**Operator: BONANZA CREEK ENERGY OPERATING COMPANY LLC**

**Location Name: Antelope B-33 Pad**

**Loc ID: 432287**

**Inspection: 713900095**

**Exhibit A**

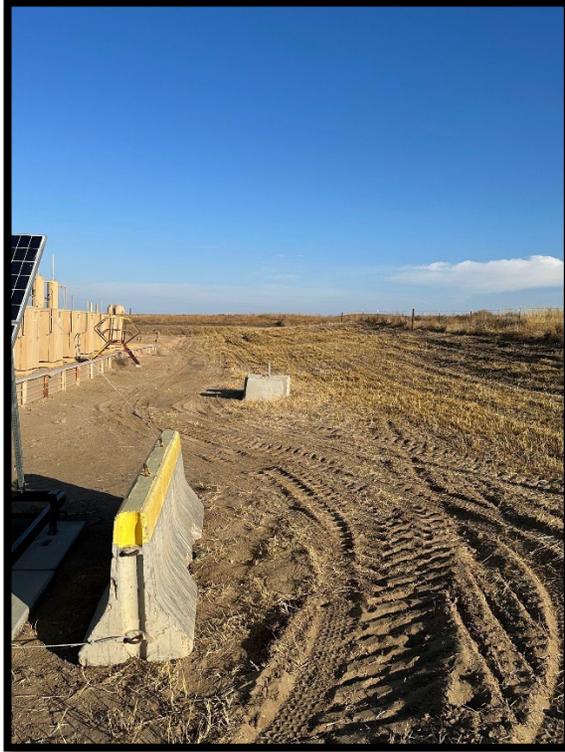
**CA:** Weed debris in the form of tumbleweeds were observed along the perimeter fence of the location. Tumbleweeds are a troublesome annual non-native weed that easily breaks off at the stem. Operator failed to control and manage weeds to prevent weed waste and prevent the spread of seeds onto adjacent lands. Comply with Rule 606 to remove weed debris.

**CA Resolution:** Operator has addressed and cleared weed debris and mowed location to comply with Rule 606.

**Exhibit B**

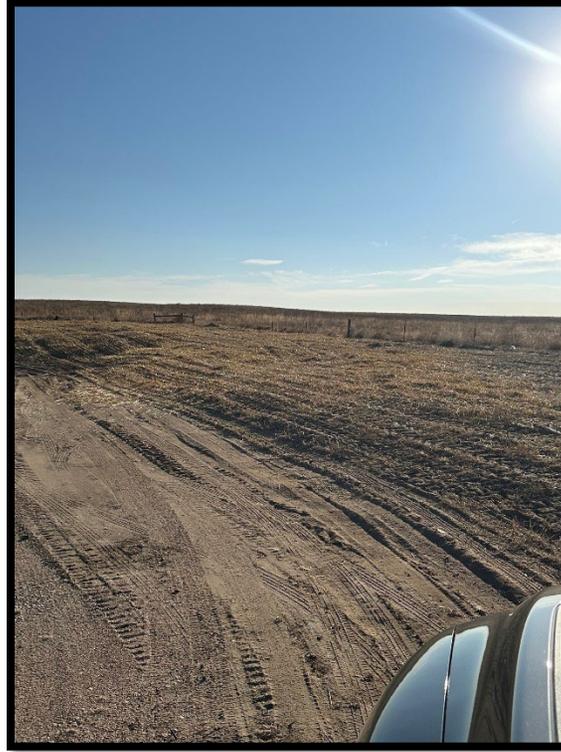
**CA:** Boards and stakes left across the location area. Refer to photo 8 as an example. Comply with Rule 606.

**CA Resolution:** Operator has addressed and removed identified trash/unused equipment on location to comply with Rule 606.

**Exhibit C**

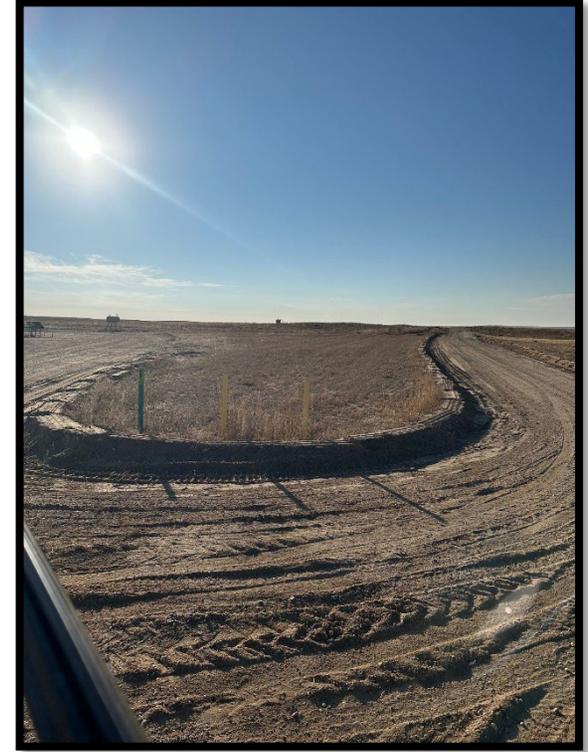
**CA:** Multiple areas of stained soil within gravel berm around risers. Comply with Rule 912.a.

**CA Resolution:** Operator has addressed and cleaned/properly disposed of stained soil to comply with Rule 912.a.
